APPLICATION NO.	FILING DATE	FIRST NAMED INVENTOR	ATTORNEY DOCKET NO.	CONFIRMATION NO.
10/791,750	03/04/2004	Kenji Takase	0951-0133P	5270

Office Action Summary	Application No.	Applicant(s)	
	10/791,750	TAKASE, KENJI	
	Examiner	Art Unit	
	Tu-Tu Ho	2818

DETAILED ACTION

FIG. 6

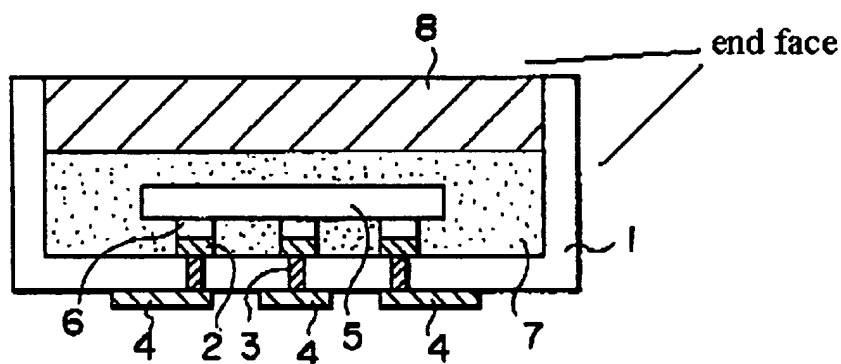
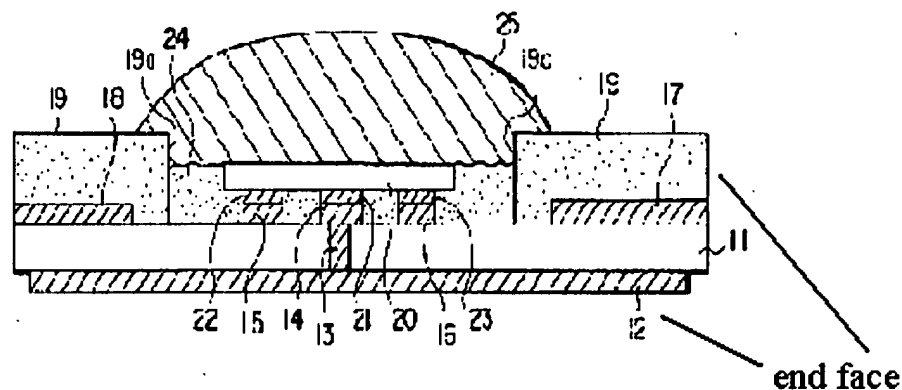
With respect to the **argument** that the reference does not disclose one or more electrically conductive patterns be formed at one or more end faces of a substrate (Remark filed 10/27/2005, Page 9), it is respectfully pointed out that the reference does disclose one or more

electrically conductive patterns be formed at one or more end faces of a substrate. See Figs. 6 and 7, reproduced below or next page.
